12 June 2024

SB Civil
C/-
Laila Alkamil
Senior Planner
Williamson Water and Land Advisory

RESPONSE TO ADDITIONAL INFORMATION REQUEST – 1618 ARARIMU ROAD, PAPAURA

Rev	Revisions	By	Date

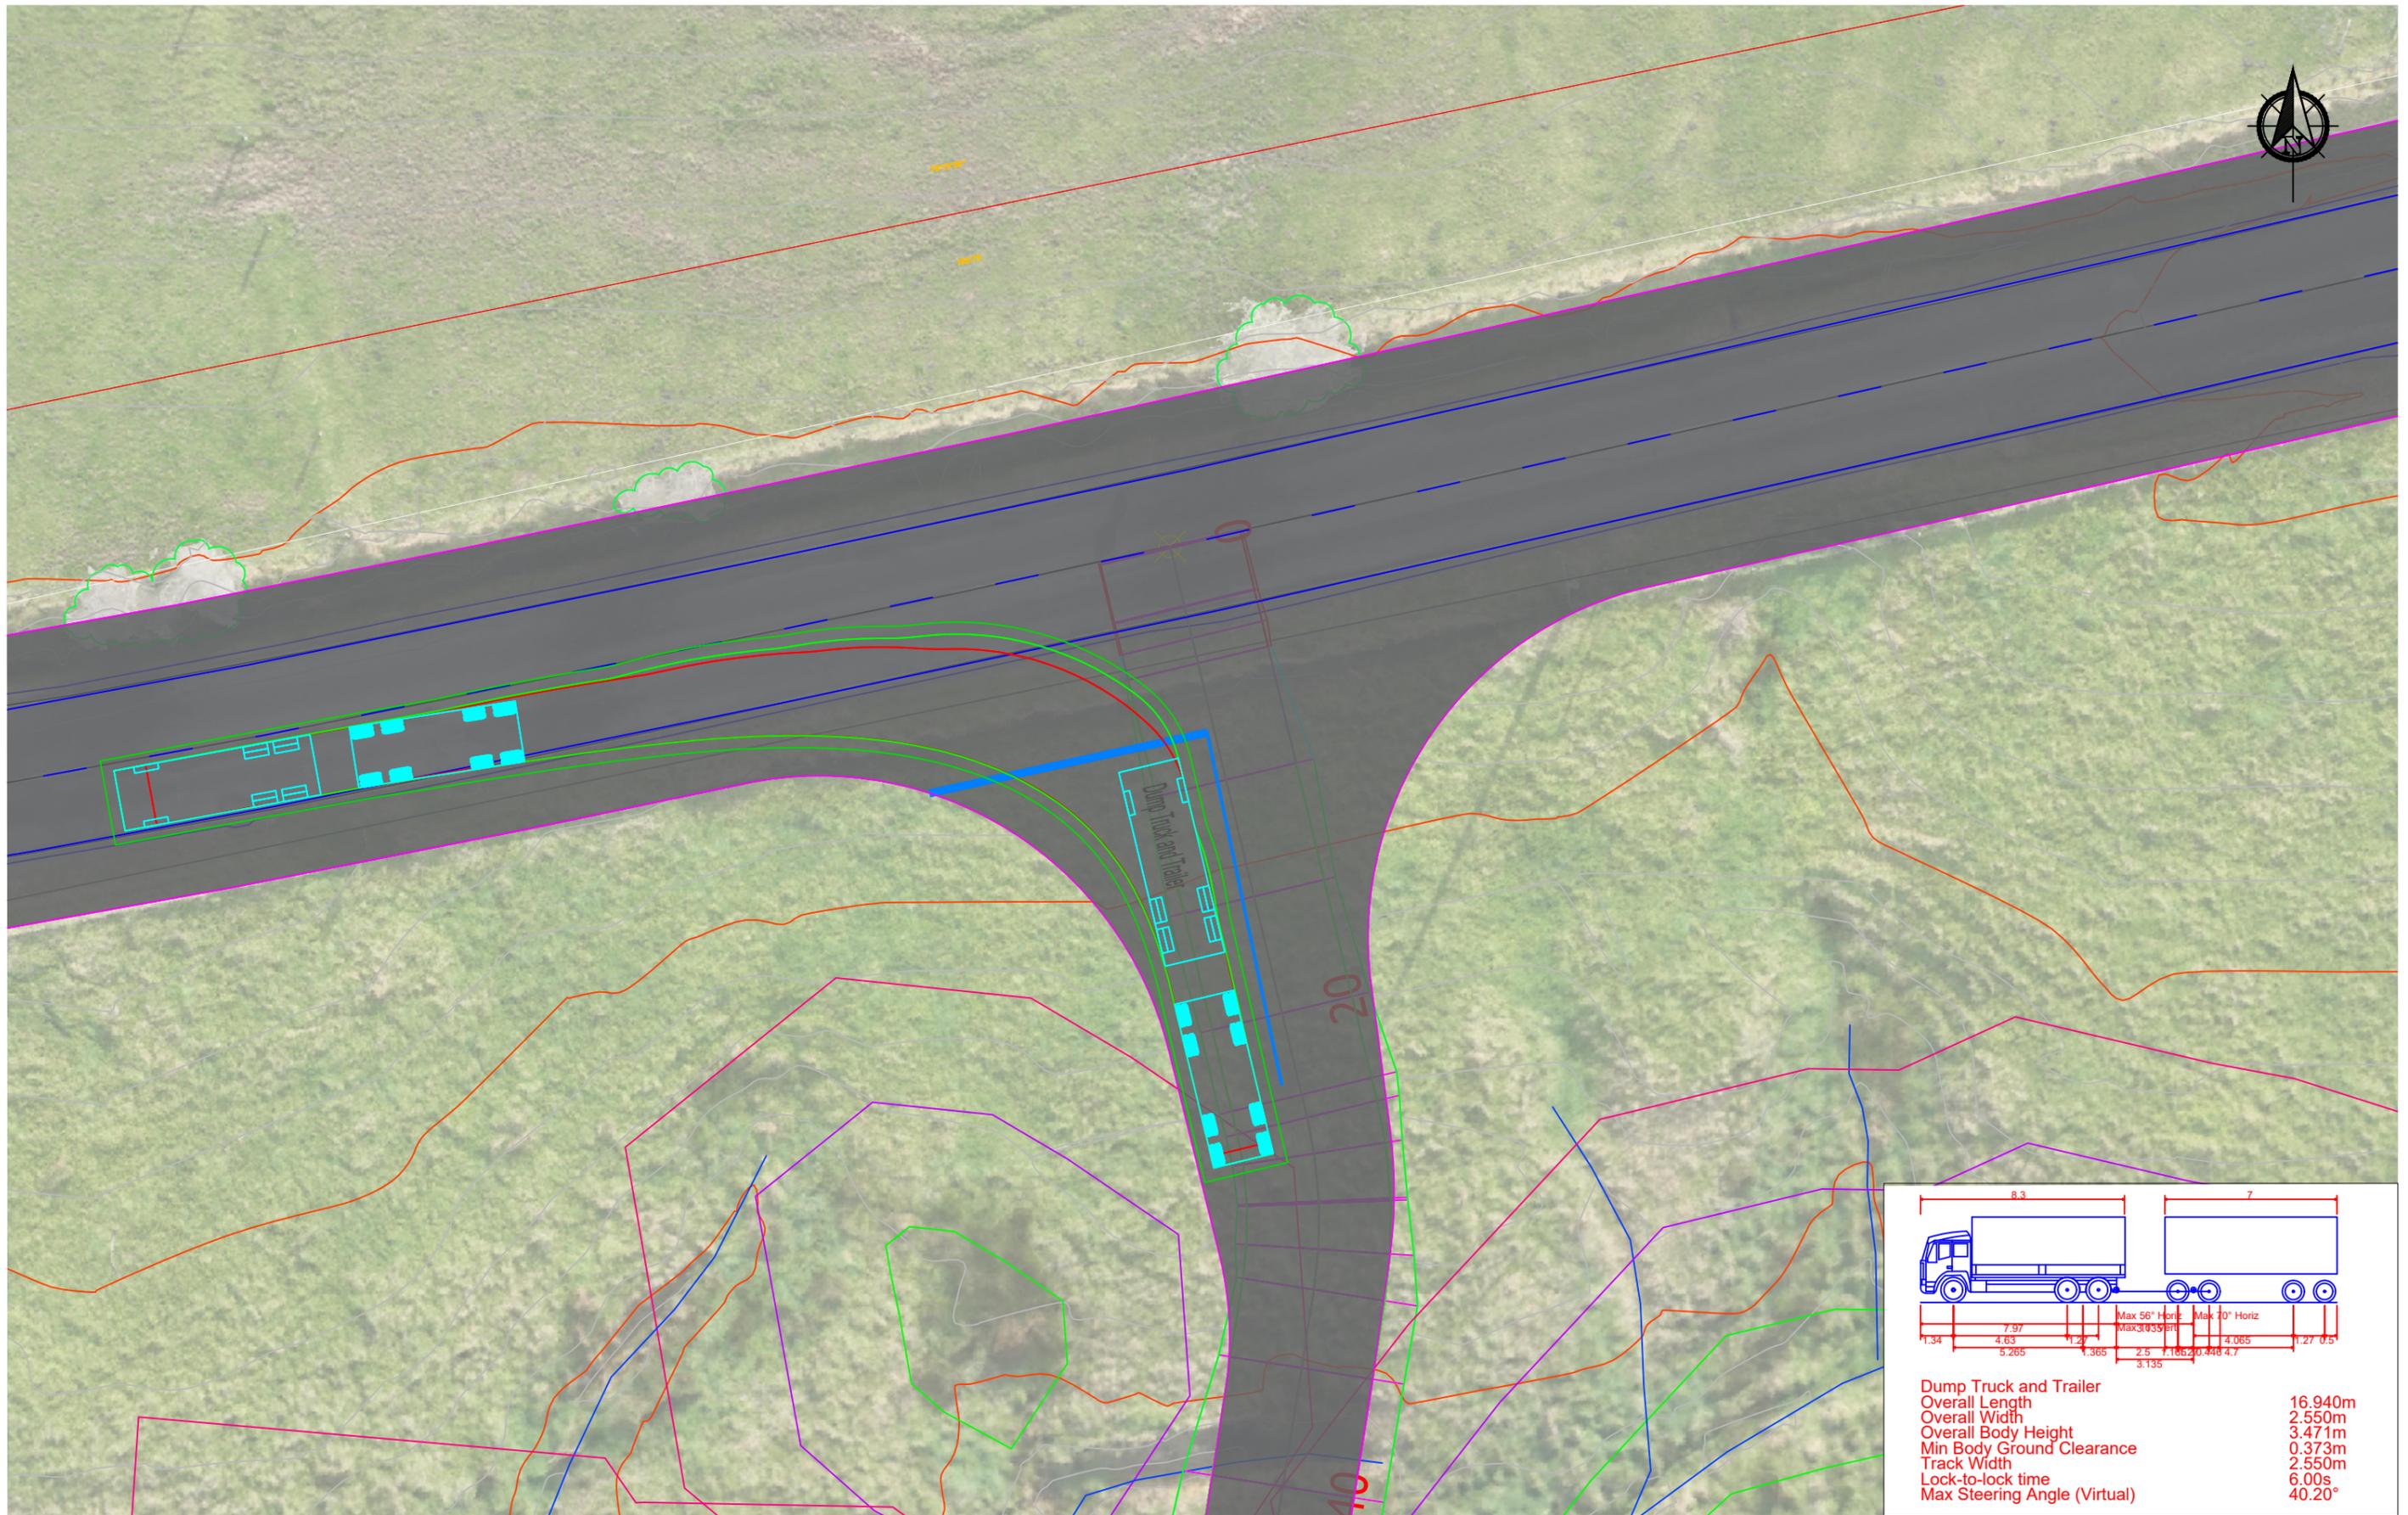
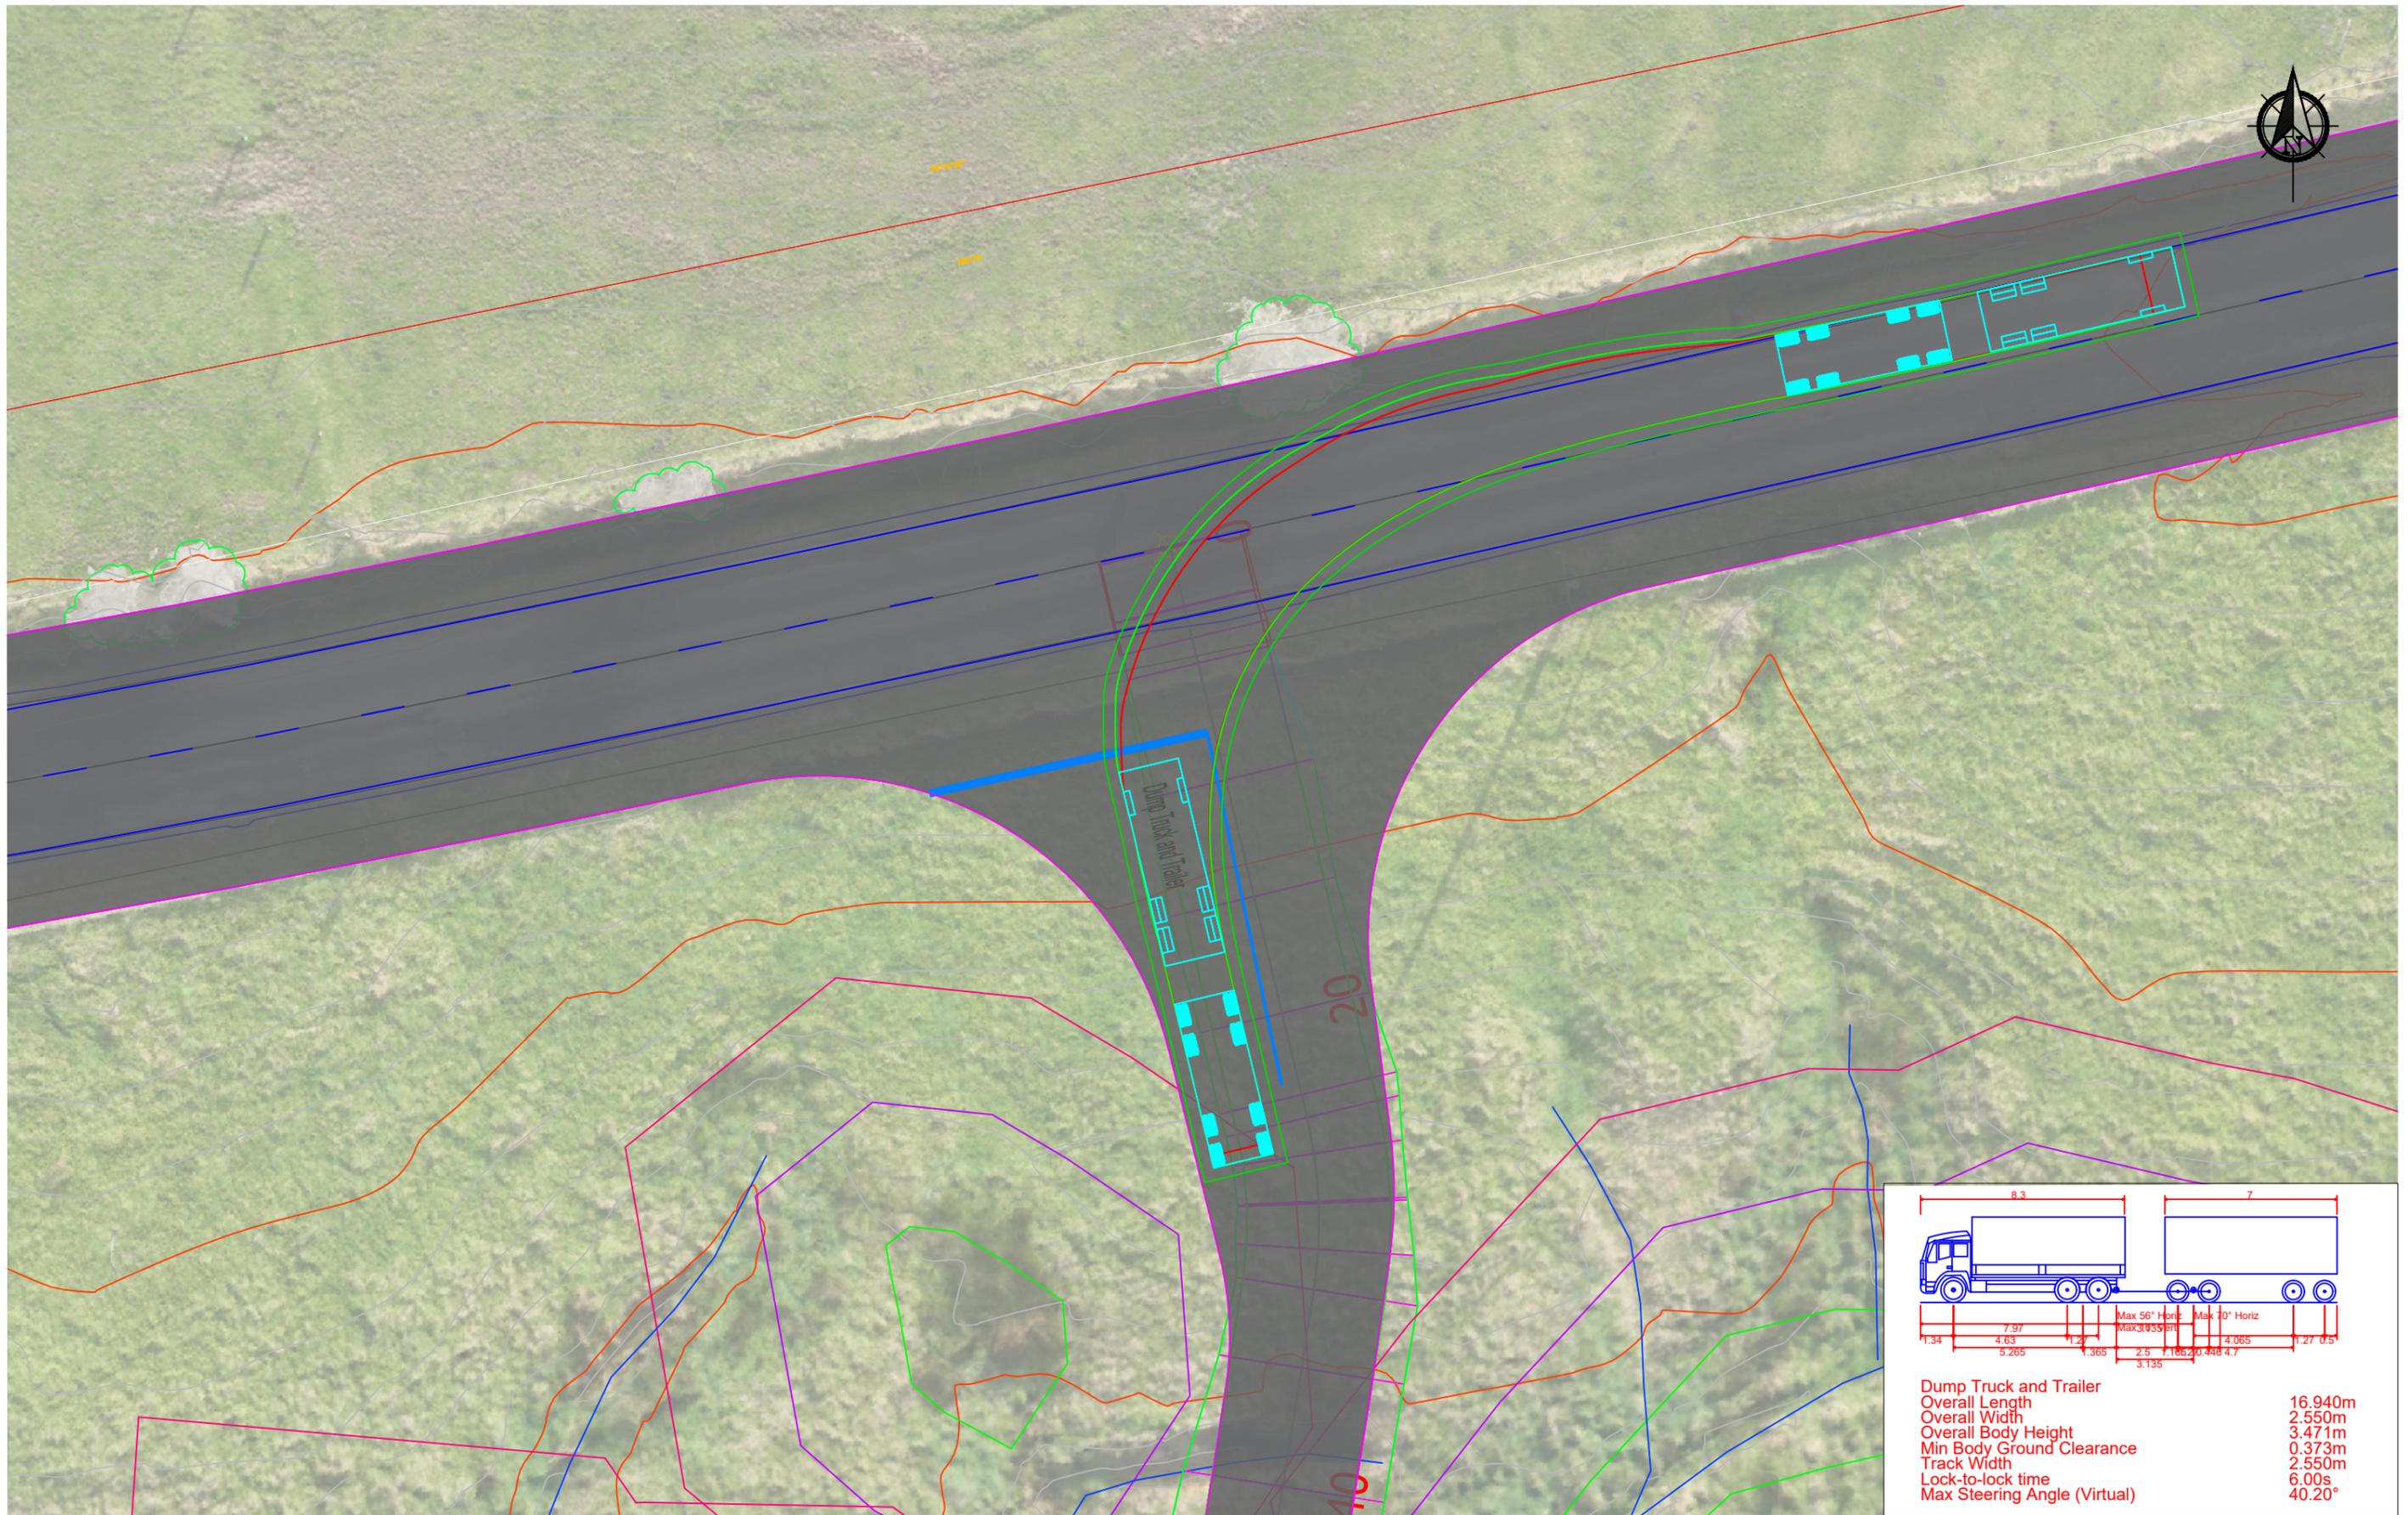
Please provide revised tracking diagrams of the 17m truck and trailer off 23m wide vehicle access after providing analysis as per NZTA's Planning Policy Manual Appendix 5B.

Updated vehicle tracking has been provided within the **Attachment** for the 17m truck and trailer, based off the vehicle crossing design as per NZTA PPM – Diagram E. It is noted that trucks can enter/exit the site with relative ease, however this is not unexpected as the increased curve radius and lane widening provides additional space. It is however noted that within increased width and radii, trucks can be expected to enter and exit the site at higher speeds compared to that of the preferred design.
